1. OVERVIEW OF THE COMMITTEE DECISION ON PLAN CHANGE 73

SUBJECT:

PROPOSED DISTRICT PLAN CHANGE 73: SUBURBAN CENTRES REVIEW

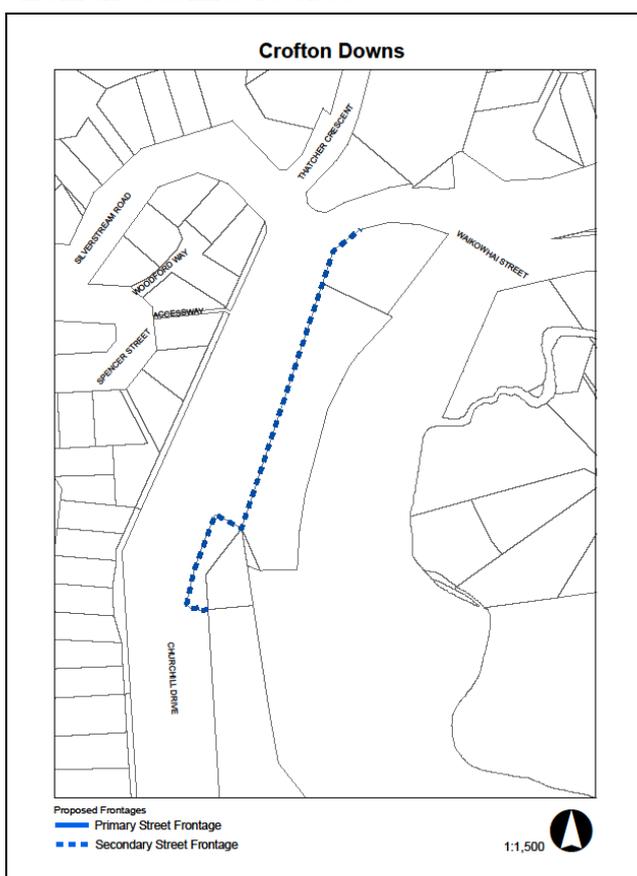
Mr Cullum disagreed with the Officers’ Report that stated the secondary frontage requirements were not overly restrictive. He felt that that the minimum building height and control over open vehicle parking areas was discriminatory and would pose problems for service stations.

Mr Cullum also expanded on why he considered the individual Shell sites at Kilbirnie (Coutts Street), Strathmore (Broadway) and Crofton Downs (Churchill Drive) should not have a secondary frontages applied.

As discussed in the general urban design section 4.5.1 of this Decision Report, the Hearing Committee had sympathy for the points that Mr Cullum raised in the written submission and at the hearing and acknowledged that there was often a tension

between standard company model fit and the Council's urban design objectives and policies.

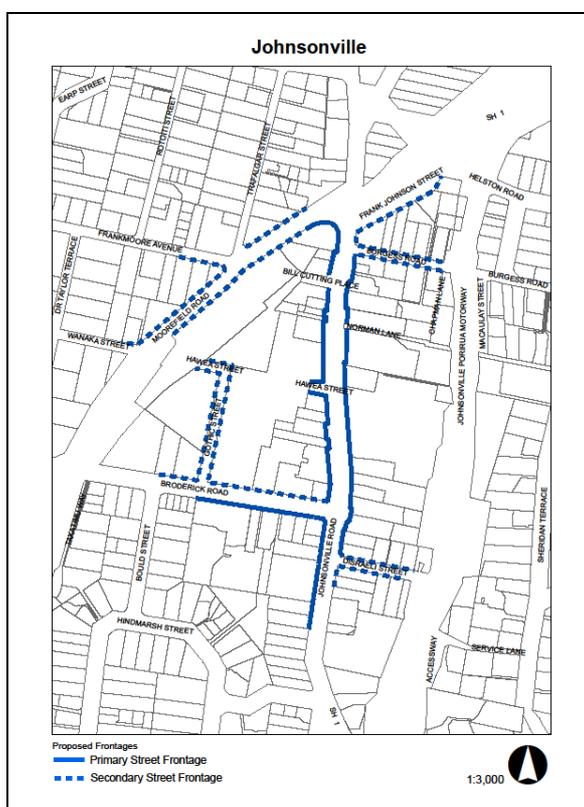
Submitter 78 (DNZ Property Group Limited) opposed the identification on Planning Map 48 (Johnsonville) of the primary and secondary street frontages on the former Hawea Street alignment between Johnsonville Road and Moorefield Road. Similarly, **submitter 31 (Wellington City Council)** sought that the Johnsonville primary and secondary street frontages map on planning map 48 be amended to delete the primary and secondary frontages on land not fronting a legal road or public space. **Further submission 13** supported this submission.

The Officers' Report agreed that was not appropriate to apply identified primary and secondary street frontages on sites that do not front legal road or a public space.

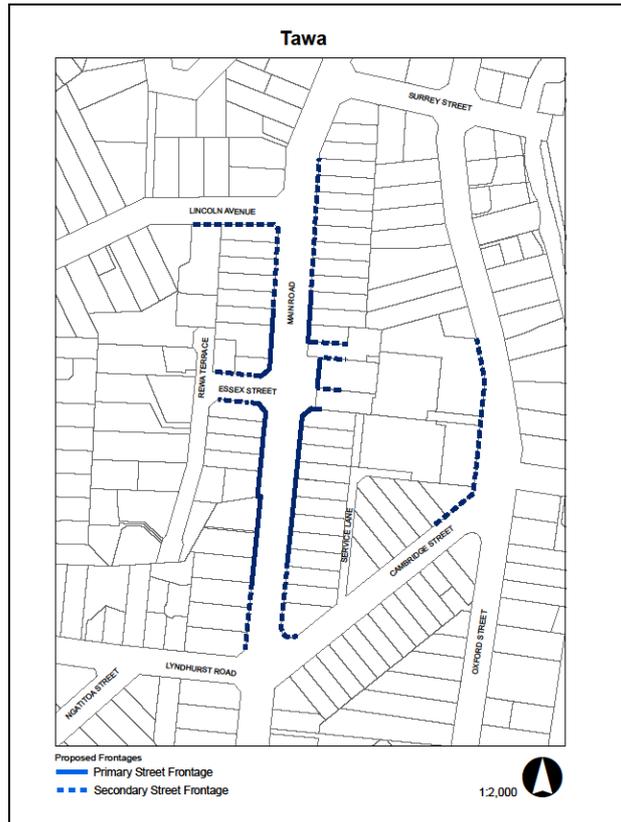
- The restaurant and drive through have been established for more than 15 years and the Company's expectation is that it will remain on the site for the foreseeable future
- The site layout and vehicle oriented nature of the activity are appropriate for the location, particularly as there is a supermarket directly opposite.
- The frontage of the supermarket is not identified as a Primary Street frontage.
- The location of two vehicle oriented activities opposite one another creates a logical boundary between the pedestrian oriented character area to the north, and the fringe area utilized by vehicle oriented activities.
- The inclusion of the McDonald's site within the Primary Street frontage imposes unnecessary hurdles in obtaining resource consents for ongoing modifications to the existing building.
- There is no continuation of the Primary Street notation to the south of the site.

At the hearing, Ms Hudson explained that the site had recently gained resource consent to upgrade the 1980s building which is set back from the road to accommodate a drive-through and vehicle access. Ms Hudson spoke of the consenting process and how it was not possible to fully extend this building to the street frontage.

Ms Hudson acknowledged the Officers' Report recommended changes to Policies 6.2.3.3 and 6.2.3.4, but did not agree that the McDonalds site was within the commercial core area of Newtown.
